# DUNE FD2-VD PDS:

## Response to PDR Recommendations

Last Update: 29 March 2023  
PDS Consortium Point-of-Contact (PoC): F. Cavanna

Figure 4. Expected event (data) rate in cathode-XA, as a function of threshold in photo-electrons

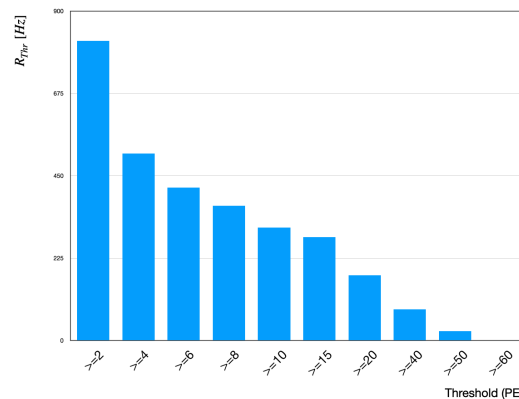
### R2. Estimate the expected data rate, as a function of threshold in photo-electrons, from all known radiological background sources, including the rates from membrane-mount modules.

- Expected  $^{39}\text{Ar}$  event rate as a function of PE threshold for cathode-mount PD modules. A study has been performed based on analytic calculations and cross-checked with existing output of preliminary MC simulations (See Document [39Ar-Rates-vs-PE-Threshold](#) linked below).

Figure 5. Light Yield maps [upper volume - transverse (x,y) plane at z=0, detector mid length] from MC simulation. [Left] Cathode only (OC 14%, 320 modules), [Right] Membrane only [OC 14%, 704 modules]

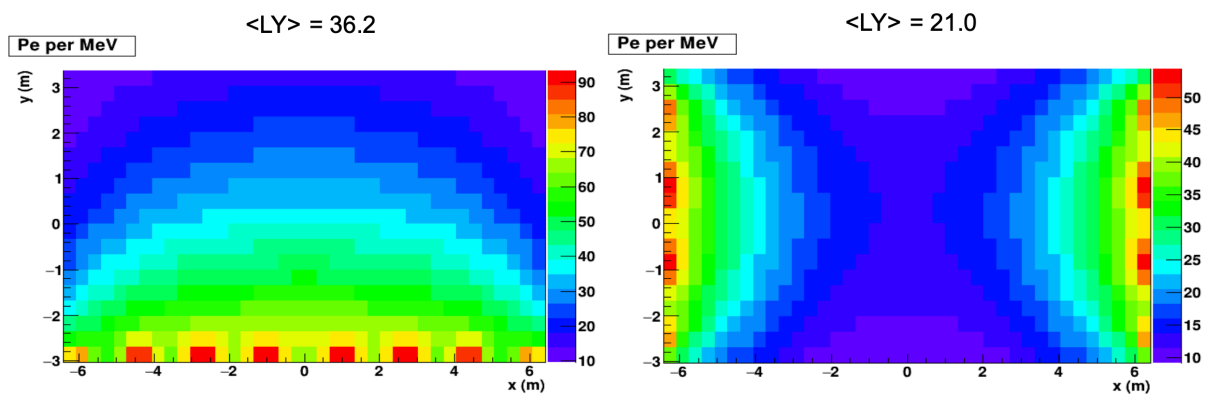
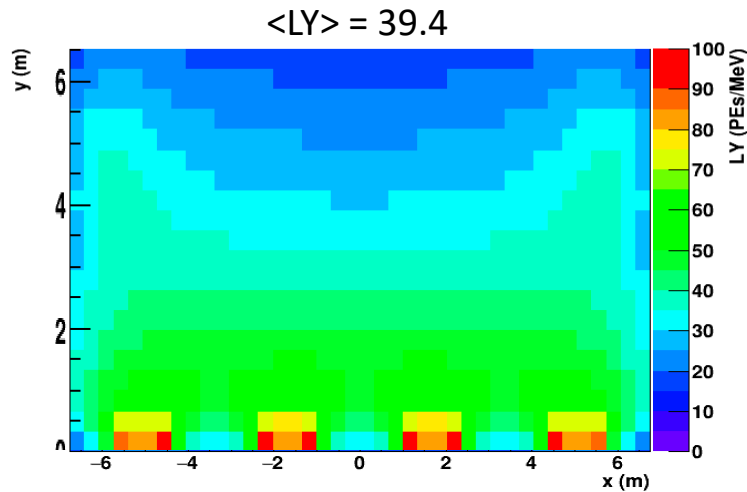
**R3. Justify the total number of modules in the system taking into account physics performance and overall cost. The justification should include a demonstration that the ratio of membrane-mount to cathode-mount modules and their geometric placement have been optimized.**

Ratio  $[N. \text{ membrane-mount modules (352)}] / [N. \text{ cathode-mount modules (320)}] = 1.1$ . In order to justify the number of cathode-mount modules vs. number of membrane-mount module it is convenient to start with the observation that the distance of any generic point in the bulk of the LAr volume to the cathode is shorter than the distance to the nearest membrane wall (on average by factor 2 shorter), therefore PD modules on the cathode have much larger acceptance for scintillation light isotropically emitted anywhere in most of the LAr volume. This suggests implementation of a larger optical coverage (OC = photo-sensitive Area/Total Area) of the cathode surface than for the membrane walls.

The optimal **ratio of membrane-mount to cathode-mount** was demonstrated by MC simulation with comparison of Light Yield maps corresponding to different coverages of cathode and cryostat walls. For example, the LY map of Fig.5 [Left] corresponds to *cathode coverage only (14%)* with 320 modules (and

no modules on the membrane walls), compared to LY map [Right] with same coverage (14%) only on the walls with 704 modules (and none on the cathode). The (average) LY is much higher with cathode-only coverage than with wall-only coverage (even with double number of membrane modules). The PDS layout of the baseline design, taking into account physics performance, overall cost and space limitations behind the field cage, was found to be optimal with 320 modules on the cathode (OC=14%) and 352 modules on the four membrane walls (OC ~7%). The modules on the cryostat walls, placed behind the 70% transparent portion of the FieldCage closer to the anode planes, have the main purpose of providing a more uniform LY detection throughout the active LAr volume (shown in Fig.6 below, from

Figure 7. Fiber bundle exit point from cathode to field cage and down to cryostat floor.

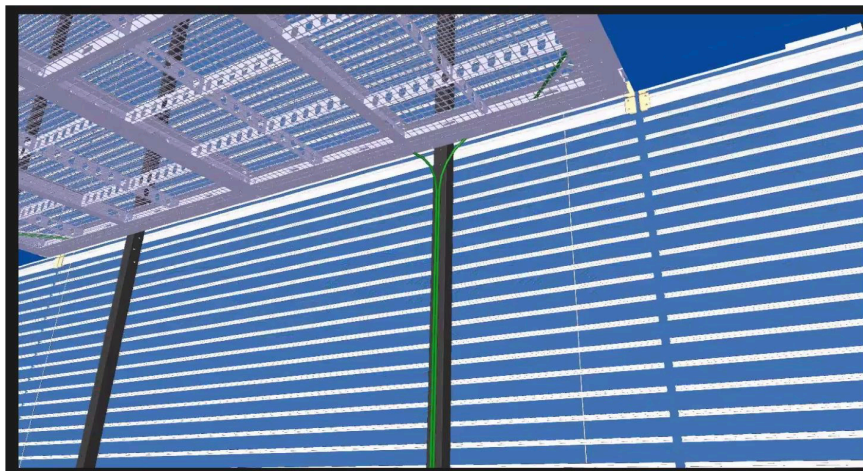
**R8. Develop a realistic installation plan for the fibers, including successful demonstration using actual fiber**

An installation plan for fibers was developed, documented, and executed for ProtoDUNE-VD Module-0 (See Document *DUNE FD2 PDS Installation Plan* linked below).

In cryostat at <2m height, cold-side team route and dress PoF/SoF fiber bundles through cathode module pair to their associated XA. Warm-side team, on cryostat roof, prepares Warm Electronics and PoF system for installation verification operation; verify fibers in associated feedthrough and connect to patch panel.

Figure 8. View from the short-side wall of the bottom and top RMS locations.

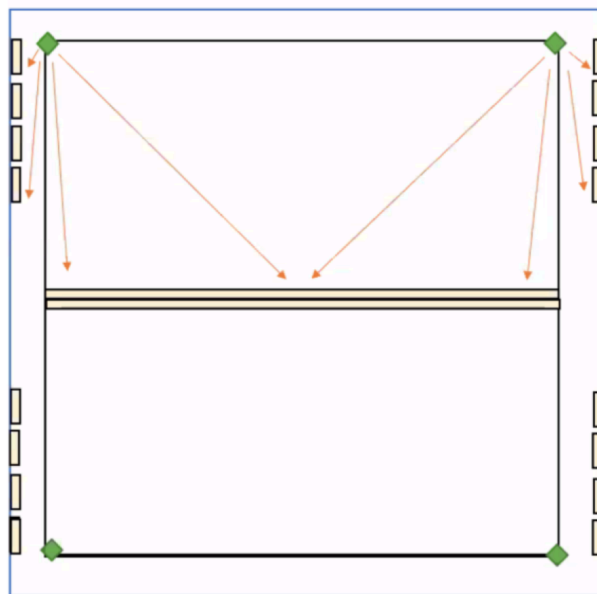
**R9. Propose a design for a monitoring system of the cathode-mount PD modules, showing how many fibers/diffusers are needed and how and where they are mounted.**

A response monitoring system (RMS) of the cathode- and membrane-mount PD modules was developed, documented, and executed for ProtoDUNE-VD Module-0 (See Document *DUNE FD2 PDS Installation Plan* linked below).

The FD2 PDS RMS components are replicated at 44 columns (2 RMS fiber diffusers kits per column) along the perimeter of the field. The RMS components to be installed at each column include (2) RMS fiber diffuser kits and (1) Flange and feedthrough kit.

Figure 9. Components of the (2) suspension cable support kits (a left and a right).

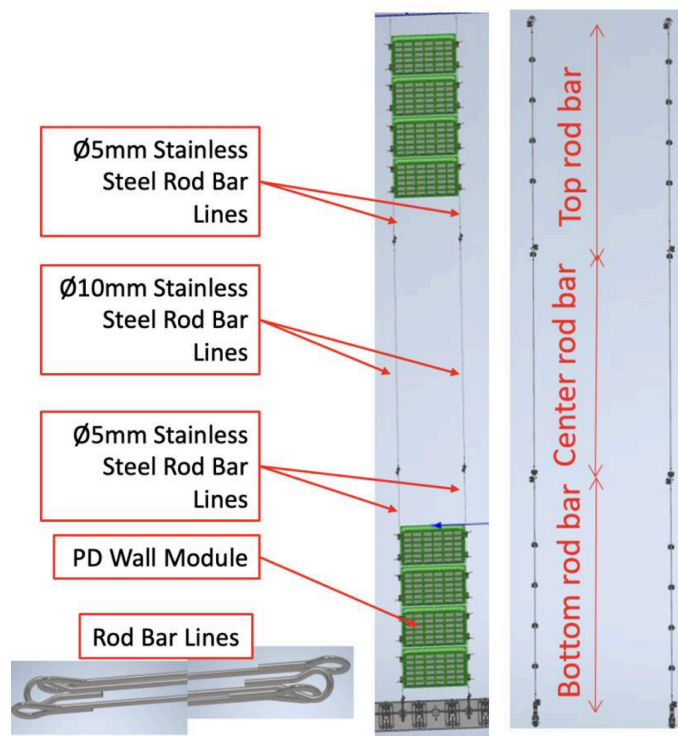
### R10. Complete the design of the mechanical support system of the membrane-mount modules, in such a way as not to preclude supporting a significantly larger number of modules on the membrane (e.g., a factor of two).

The mechanical support system of the membrane-mount modules, was developed, documented, and executed for ProtoDUNE-VD Module-0 (See Document *DUNE FD2 PDS Installation Plan* linked below).

The mechanical support for the FD2 PDS Membrane-mounted XAs is made by a suspension support kit of 2 vertical parallel cables, 8 XA per column, replicated at 44 columns along the perimeter vertical membrane walls of the cryostat, and by (4) XA HV-shield mesh kits per column.

While the mechanical support has the capability to hold a larger number of XAs per column if necessary, the baseline design of FD2 PDS, with its (44 x 8) 352 membrane-mount modules and 320 cathode-mount modules does not require additional of modules on the membrane walls.

Figure 10. Membrane-mount XA shielding mesh and photo from Module-0 installation

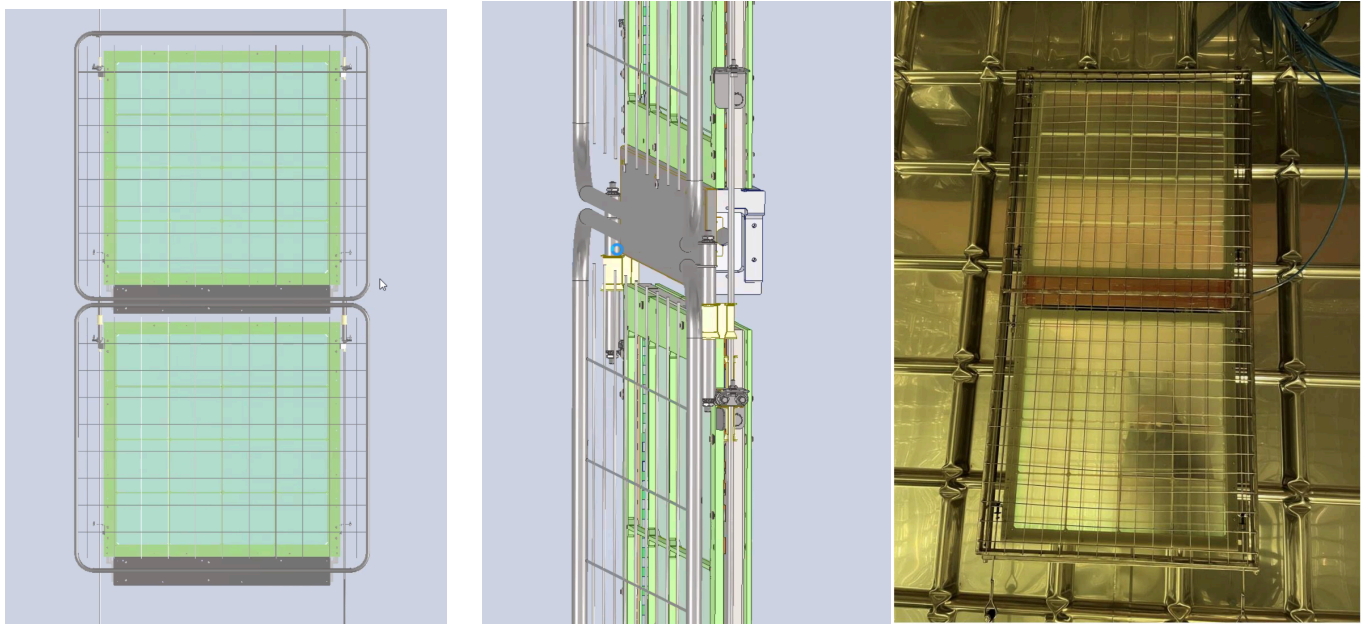
**R11. Evaluate the possibility of charge accumulation on the detector surfaces facing the field cage, discuss possible solutions with the HV group, and include the effect of any mitigating shield on the light detection efficiency.**

Charge accumulation on membrane-mount detector surfaces facing the field cage was simulated, with mitigations documented and executed for ProtoDUNE2-VD Module-0 (See Document *DUNE FD2 PDS Installation Plan* linked below).

In response to the understanding of the impact of the HV system breakdown, mitigation strategies were developed for the FD2 PDS Membrane-mounted XA:

- Membrane-mount XA shielding mesh was adopted to minimize charge buildup on the non-conductive surfaces of the XA.
